BEACON PLANNING BOARD
Via Video-Conference
BEACON, NEW YORK 12508
Phone (845) 838-5002 Fax (845) 838-5026

Conklin Street - Beacon Views

Continue public hearing for SEQRA environmental review on applications for Subdivision and Site Plan Approval, "Beacon Views Townhouses" 39 units, Conklin Street, submitted by Beacon Views, LLC

RE: Beacon Views Site Plan and Conservation Subdivision
Conklin Street
Beacon, New York
Tax Parcel ID: 6055-03-331123

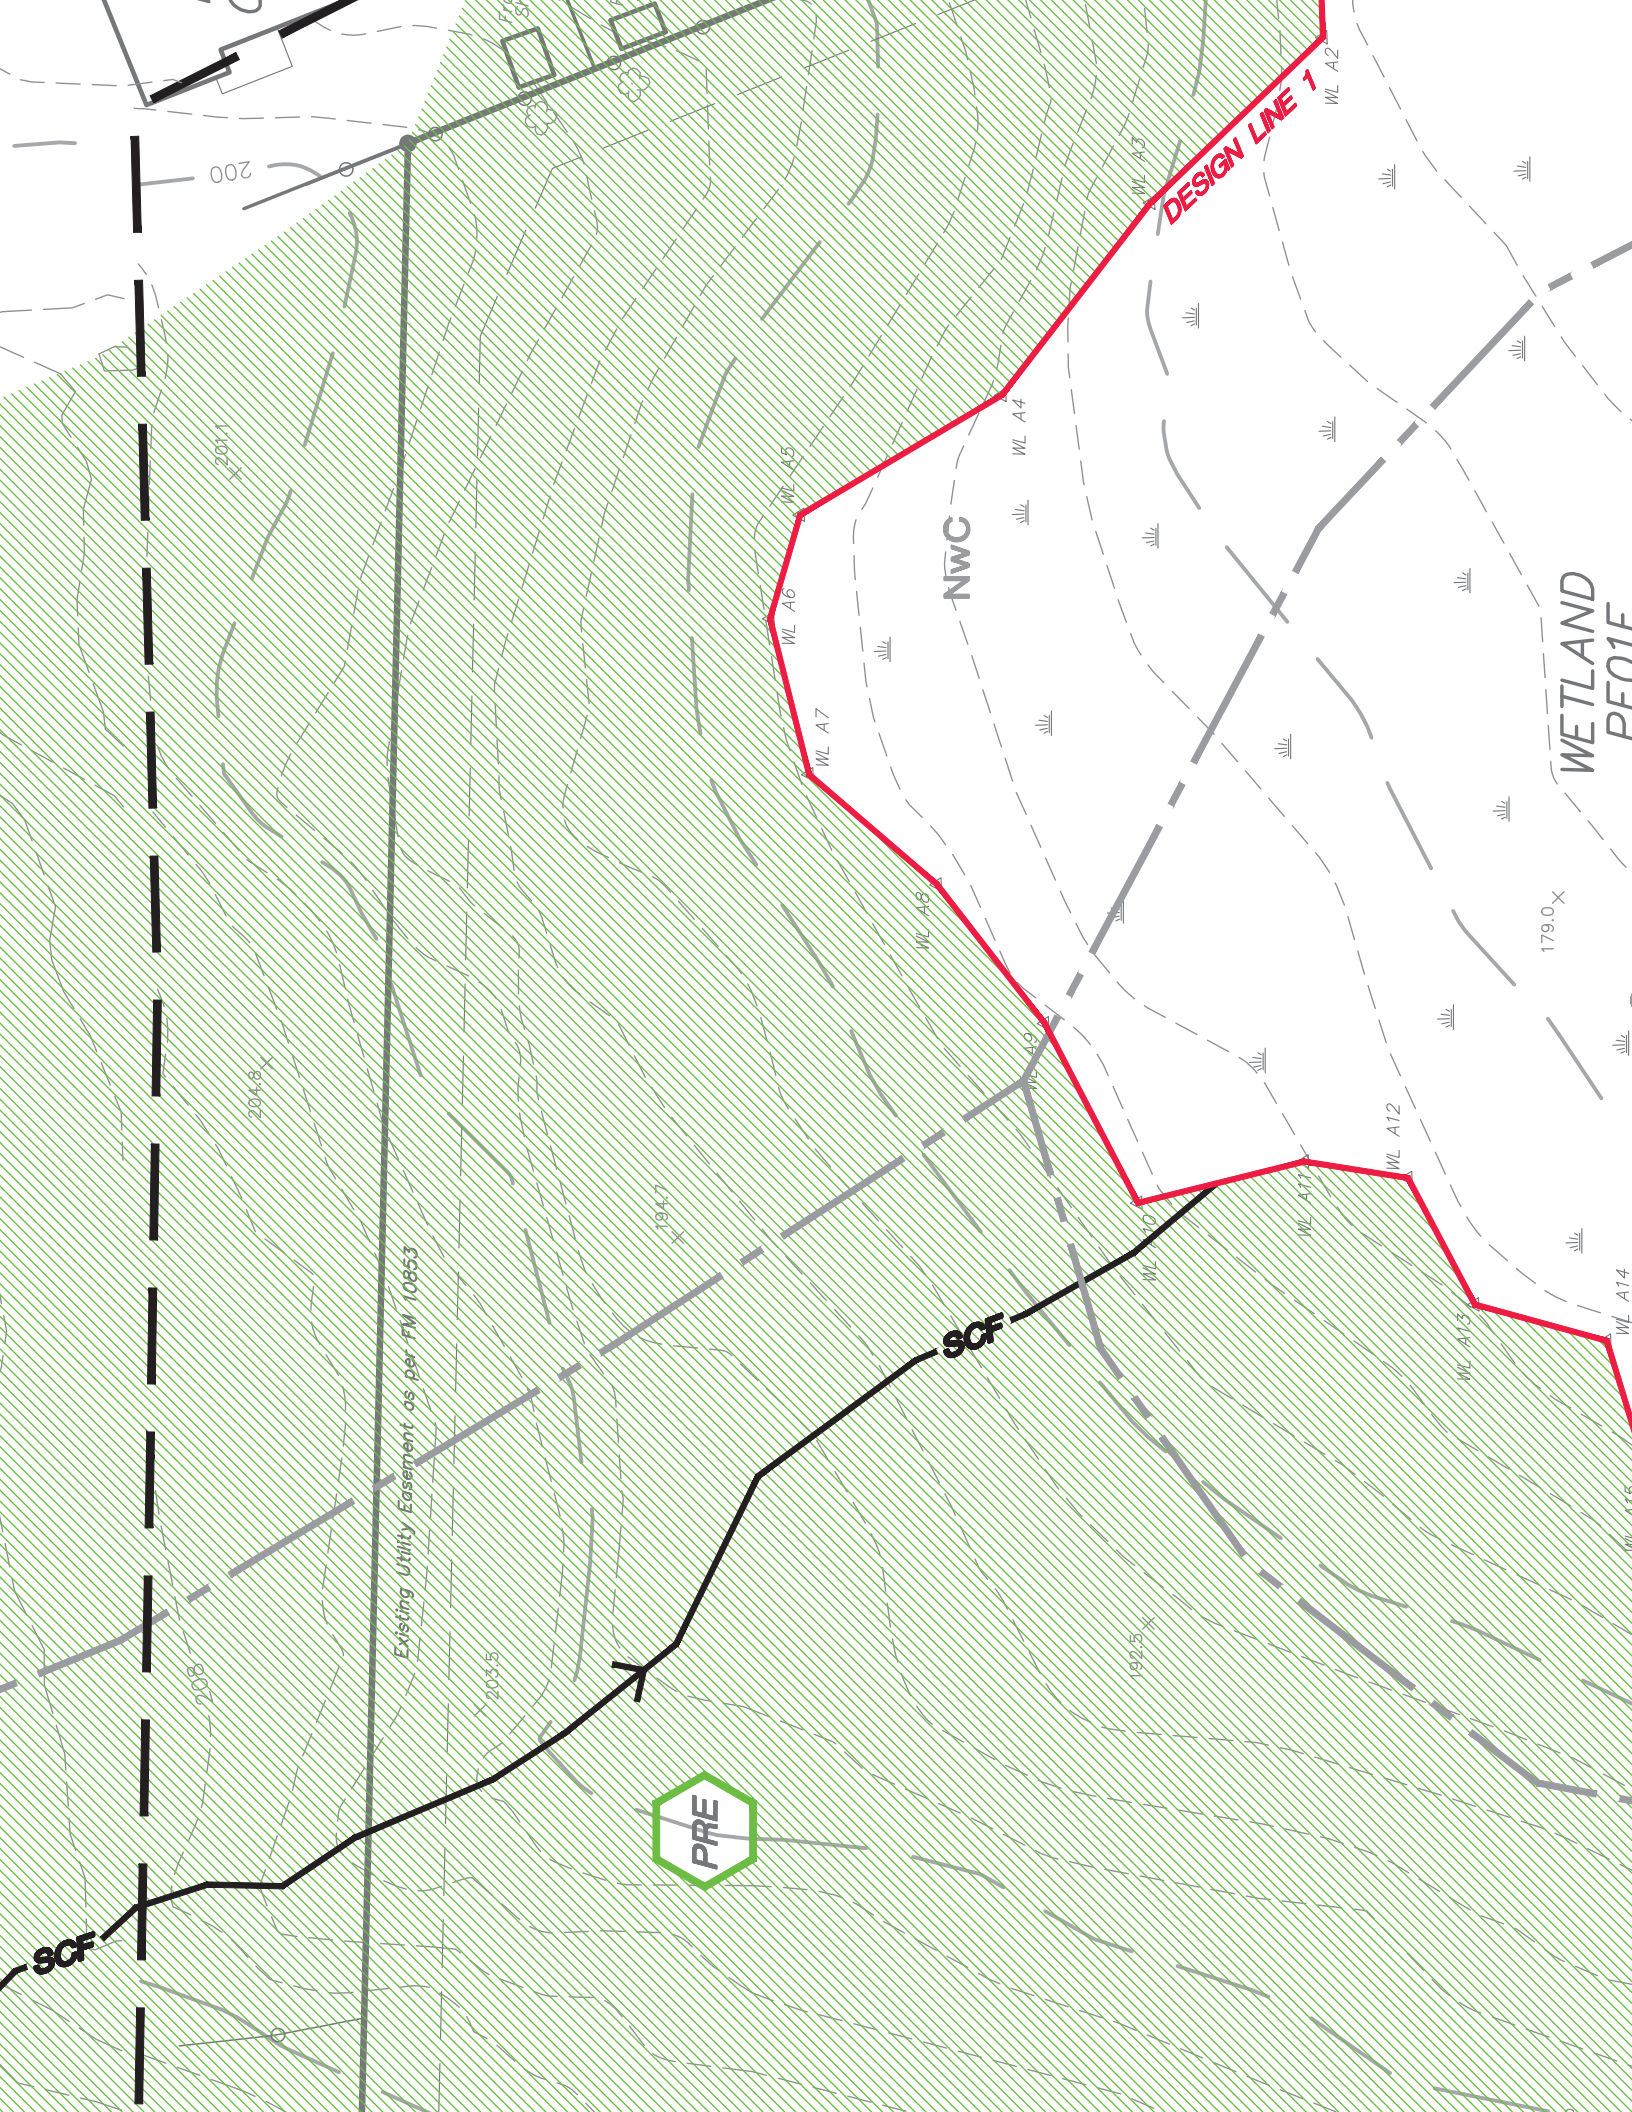
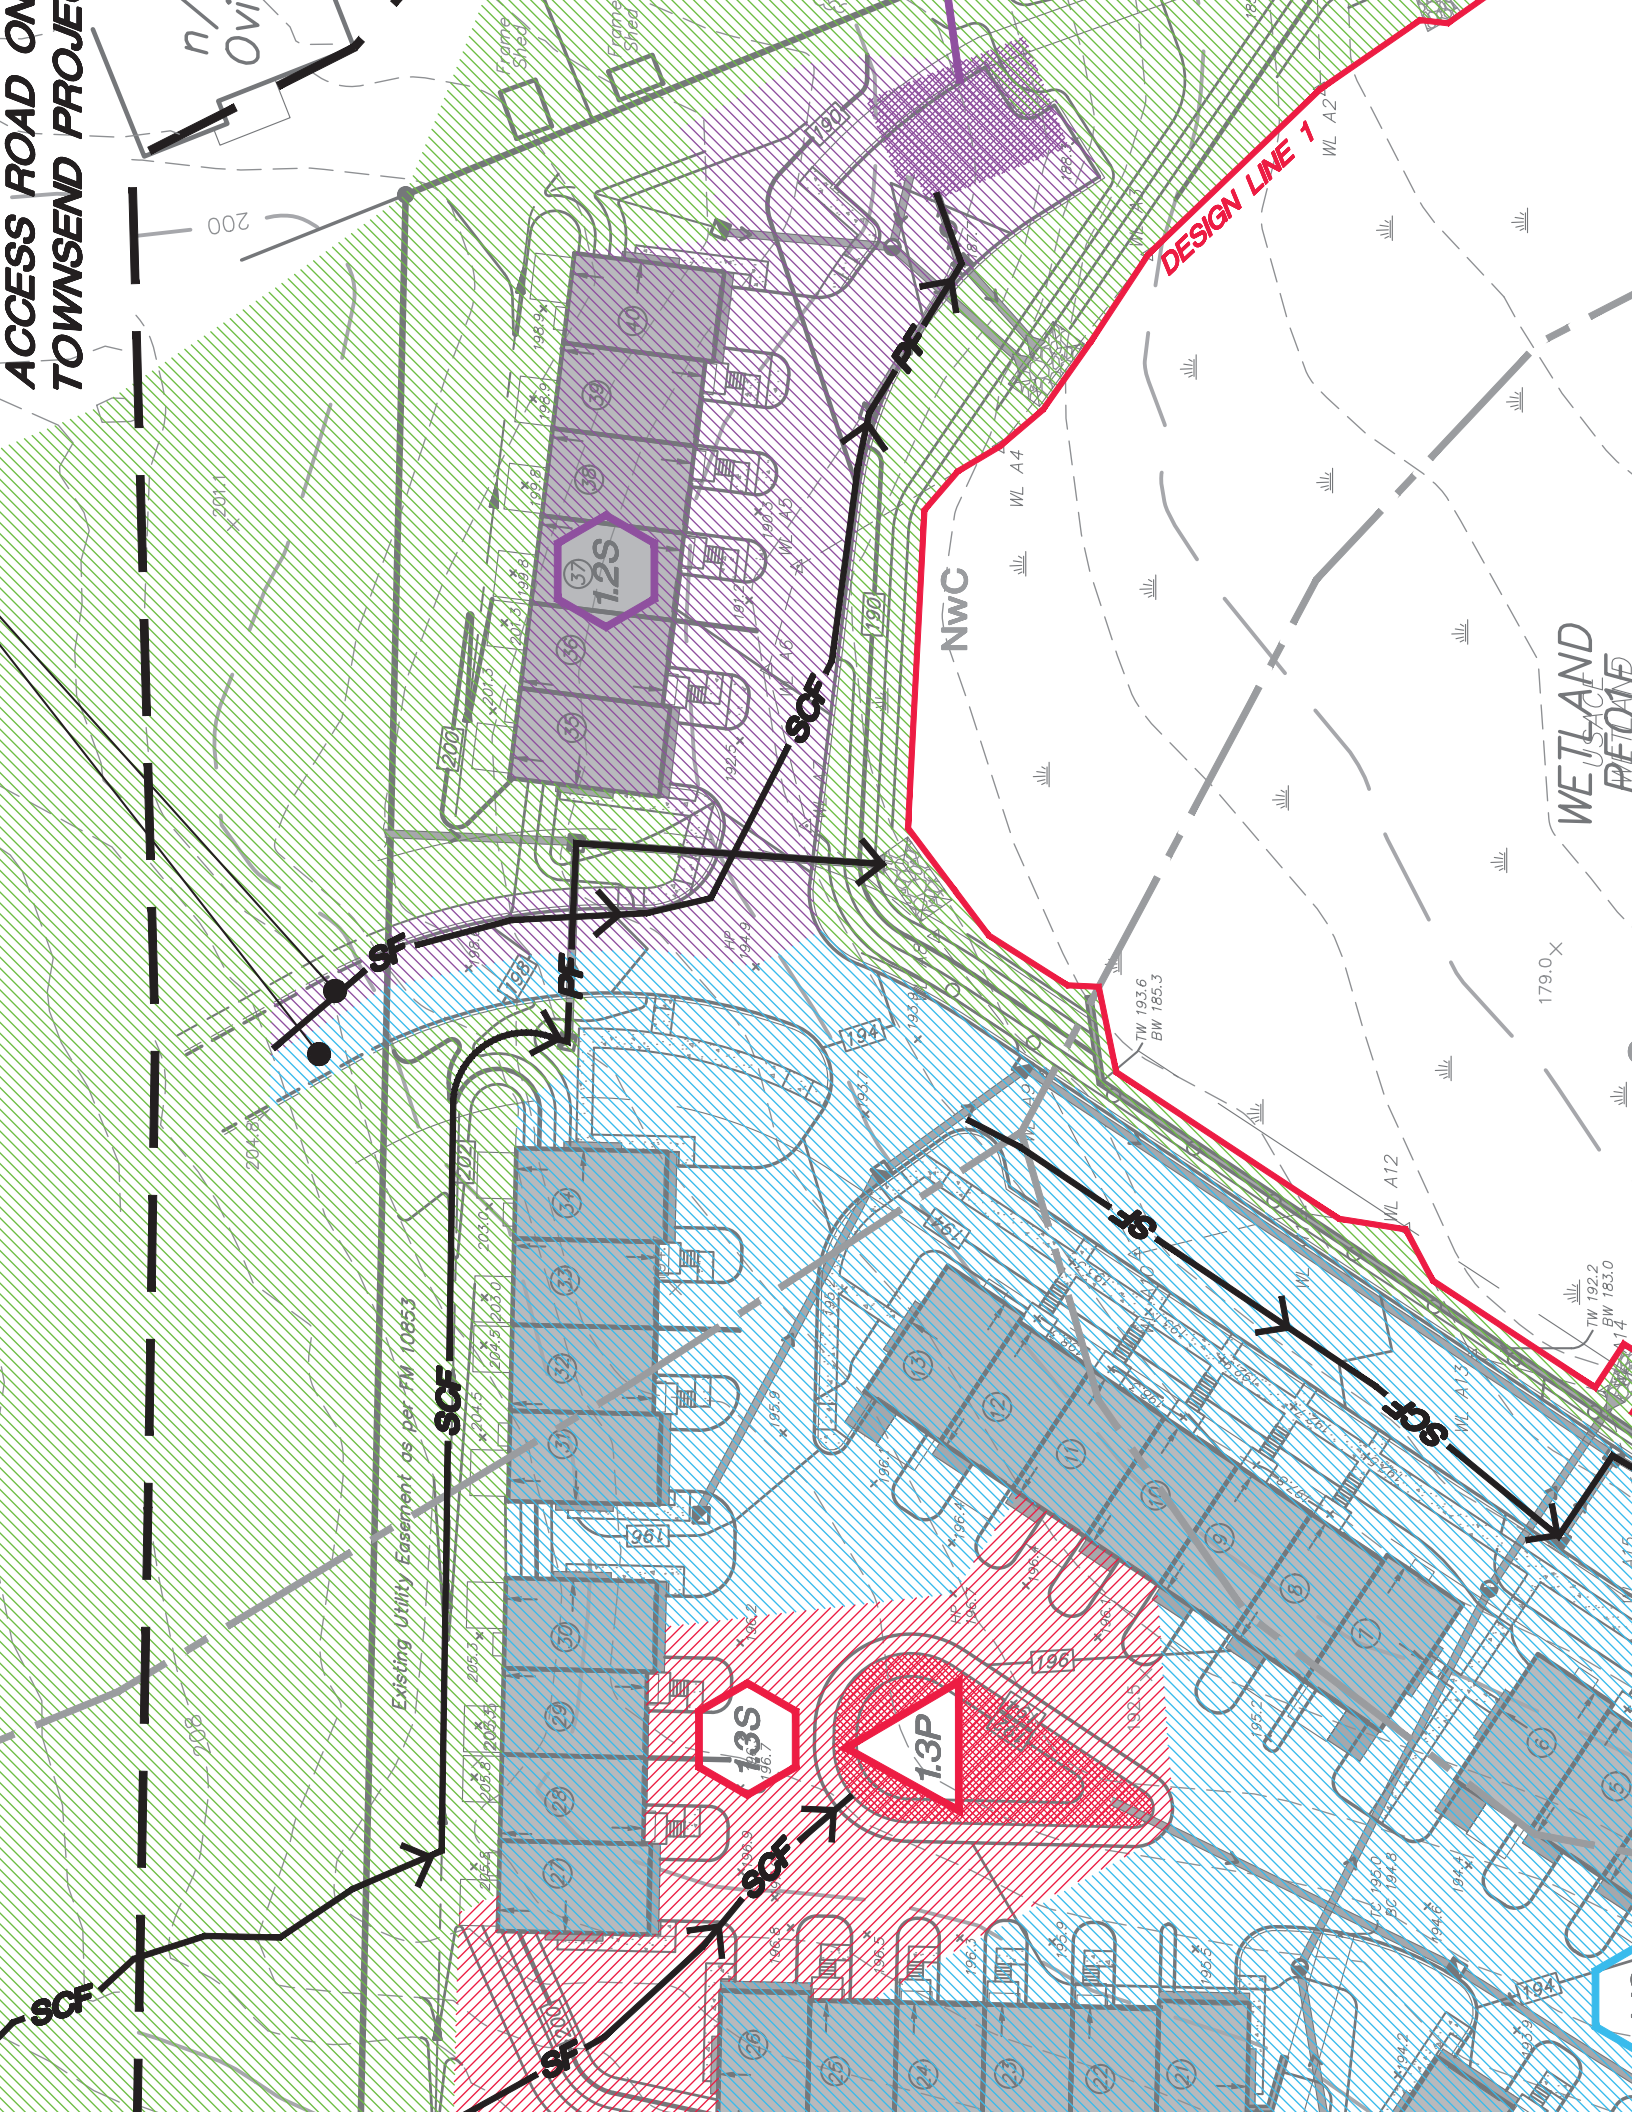
2. The subcatchment PRE on Figure 2 and subcatchment 1.0S on Figure 3 have been revised to remove the portion of the subcatchment to the north that does not drain to the south towards the design line.

6. The change in topography data has been indicated on Figure 2 and Figure 3 of the project SWPPP.
7. Additional information regarding each subcatchment has been included in Section 1.2 and 1.3 of the project SWPPP.

9. Please provide large scale maps for figures 2 and 3 within the SWPPP report.
10. Access road proposed to connect to 25 Townsend is a part of the Beacon Views project and should be accounted for within the SWPPP design for Beacon Views, the two additional catch basins shown within the proposed access road on the 25 Townsend project site should be removed.

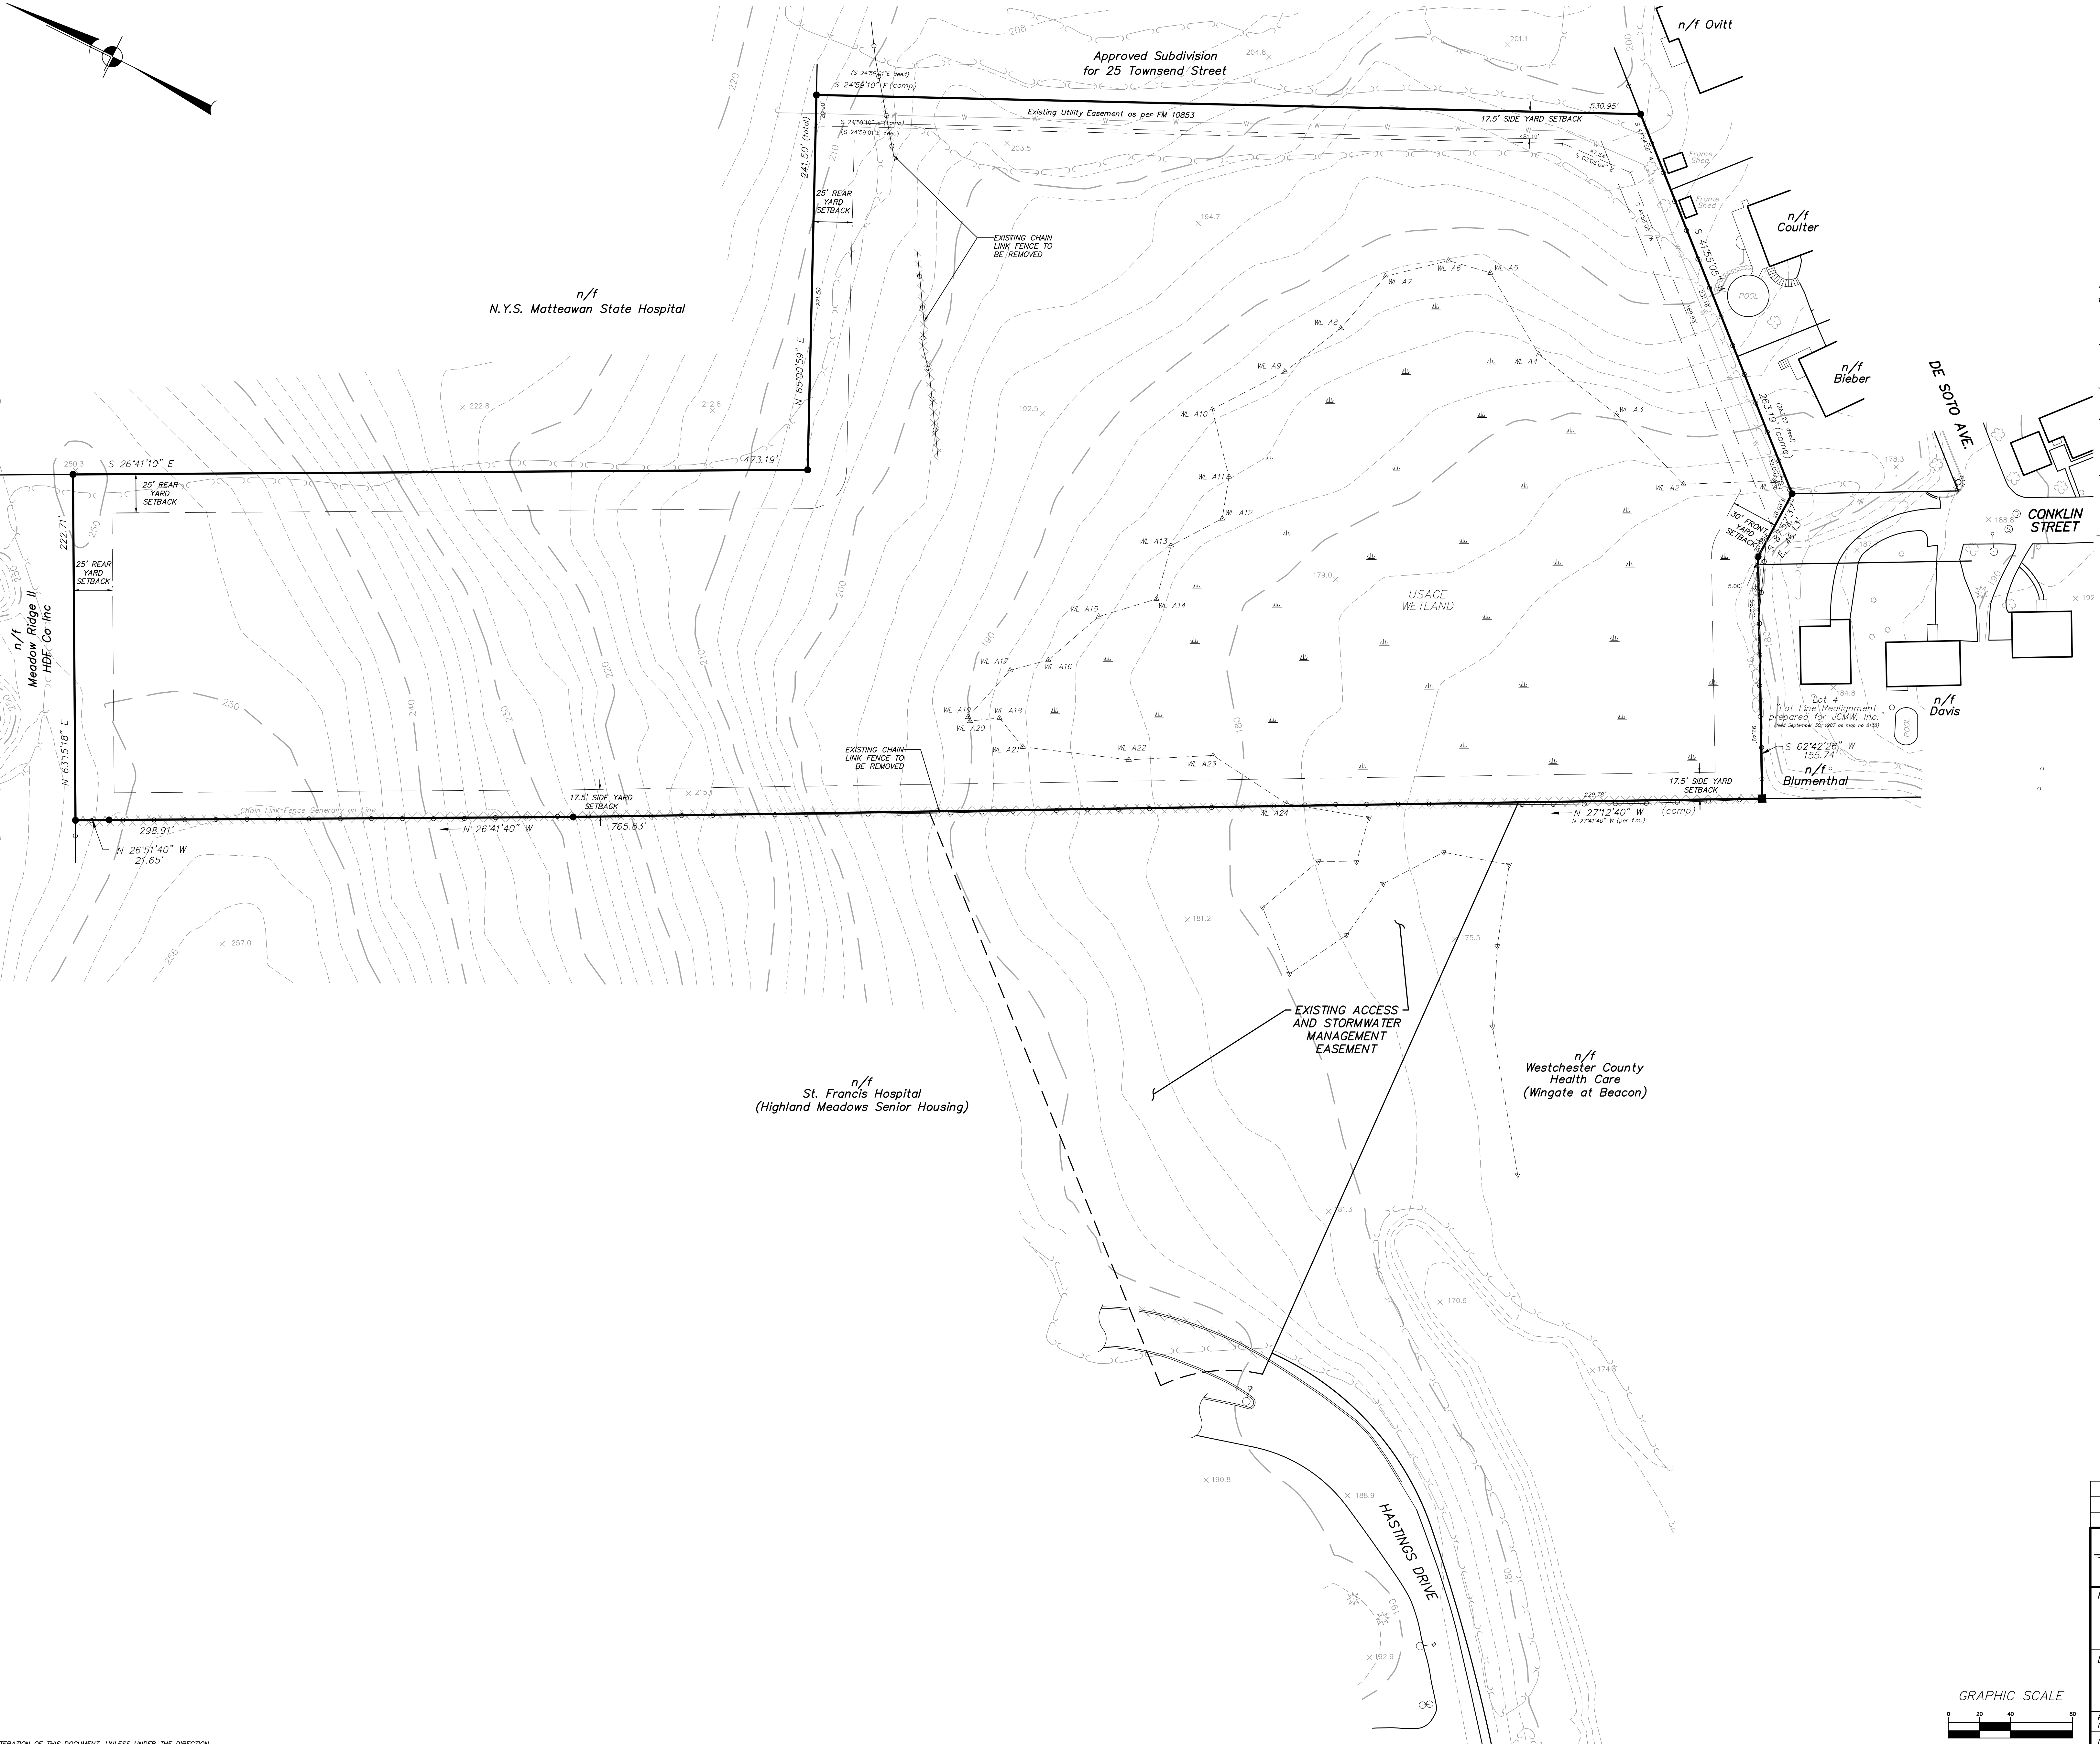
1. The existing low rubble retaining wall as shown on the plan has been field verified. Though the Blumenthal driveway within the City right of way is surrounded by steep slopes there is no other wall in the area.

2. The plan has been revised to indicate that the wetland is a Federal wetland, regulated by the United States Army Corps of Engineers. A note has been included to address the delineating party and date.
